2007/2008 PROPOSED CHANGES TO THE INTERNATIONAL ENERGY CONSERVATION CODE

ENERGY CONSERVATION CODE COMMITTEE

FIGURE N1102.1 PROJECTION FACTOR

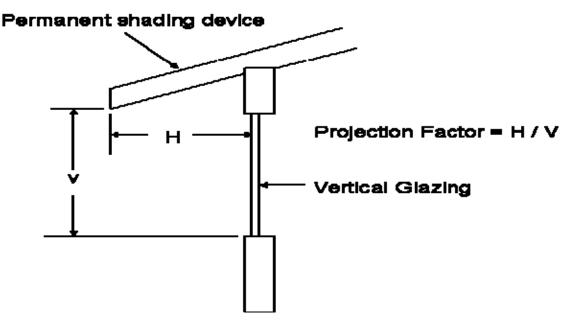
h. Fenestration with a projection factor of ≥ 0.50 shall comply with the following SHGC requirements: Climate Zone 1-NR; Climate Zone 2- NR; Climate Zone 3 - NR. Projection factor shall be determined using Figure 1102.1.

Reason (Part I): This proposed code change allows for the use of overhangs to meet the solar heat gain coefficient requirements within the IECC. Overhangs are considered permanent exterior shading devices and are allowed to be used in IECC Chapter 5 as a prescriptive trade-off to meeting the SHGC requirements within the code. The calculation for determining the projection factor for overhangs has been in the 2000, 2003 and 2006 IECC for commercial buildings and has been proven to be very simple to calculate, fitting well into a prescriptive approach. The overhang credit is orientation independent to match the simplicity of the SHGC requirement in Table 402.1.1.

Reason (Part II): This proposed code change allows for the use of overhangs to meet the solar heat gain coefficient requirements within the IRC. Overhangs are considered permanent exterior shading devices and are allowed to be used in IECC Chapter 5 as a prescriptive trade-off to meeting the SHGC requirements within the code. The calculation for determining the projection factor for overhangs has been in the 2000, 2003 and 2006 IECC for commercial buildings and has been proven to be very simple to calculate, fitting well into a prescriptive approach. The overhang credit is orientation independent to match the simplicity of the SHGC requirement in Table 402.1.1.
